## Access Compliance Report Public Rights-of-Way (Curb Ramps)

Intersection ID: 26553 Main Street: KUYKENDALL\_RD Cross Street: THORN\_BLADE\_DR Location: SE

ADA ID: 95C5290CC09A Ramp Type: Perp Initial Pass/Fail: Fail Overall Compliance: No Severity Score: 12.5

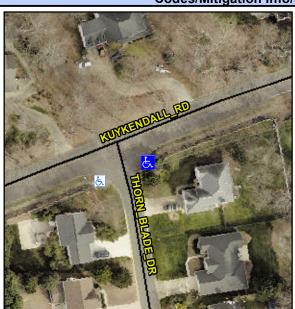
Possible Solutions:	Com
Remove & Replace Entire Ramp.	N/A
	Yes
	N/A
	N/A
	N/A
	N/A
Surveyor Notes:	N/A
N/A	N/A
	N/A
	N/A
	N/A
PROW/ADA:	N/A
Not Found, R304.2.2	N/A
	N/A
	N/A
	N/A
